Groundwater Transfer Review Summary Form

Transfer/PA # T- 13836

Application: T-13836

Applicant Name: City of Prineville

Transfer Map

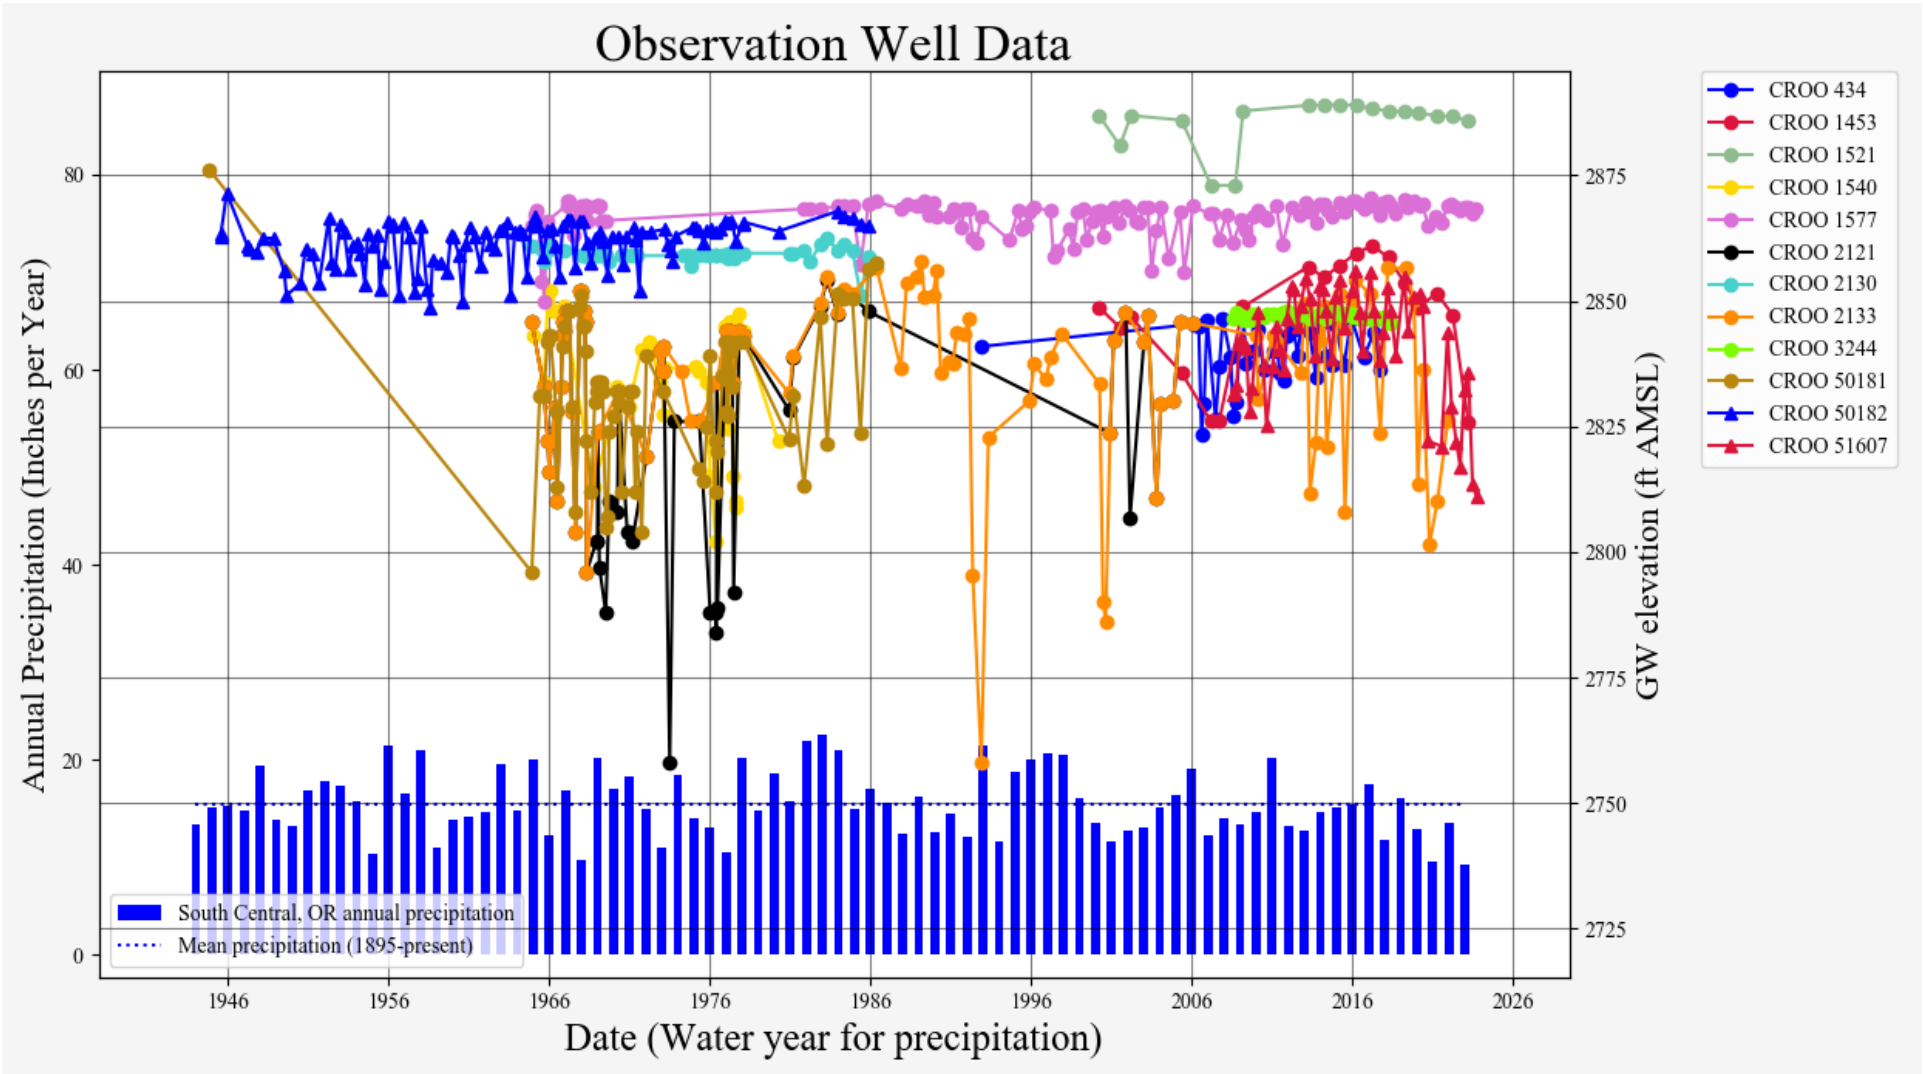
☐ Yes ☒ No If yes, explain: For 4 of the wells (Juniper Well, 5th & Deer St. Well, Yancey Well 3, and 4th St. Deep Well), groundwater production would remain very close to a current valid POA. Any increase in well-to-well interference would not be expected to be significant. Additionally, the Department is currently unaware of problematic interference caused by the current POAs in the target aquifer.

Conversely, Stearns well 3 is located 1.25 miles east of the nearest POA under permit G-18482 and thus would move groundwater production into an area that did not have acute impacts from this water right before. The nearest senior groundwater users accessing the target aquifer are CROO 3132 and CROO 2083 under the City of Prineville's certificate 94816. Because these POAs are owned by the applicant, they are not included in an injury analysis. The nearest senior groundwater user accessing the target aquifer appears to be one or more domestic wells (e.g. CROO 2183) on the Ochoco Lumber site approximately 3000 feet to the west. A Theis (1935) distance drawdown model using published transmissivity values indicates full appropriation at the maximum permitted rate could result in drawdown of 80 to 150 at CROO 2183. While that degree of drawdown could be considered injurious, it is extremely unlikely that Stearns Well 3 could pump at 3.99 cfs for long enough to cause such high magnitude interference. Thus, the potential interference with senior groundwater users from the proposed changes is not considered to be injury. In light of the potential for groundwater interference, OWRD will track seasonal and year-on-year water level trends in the area.
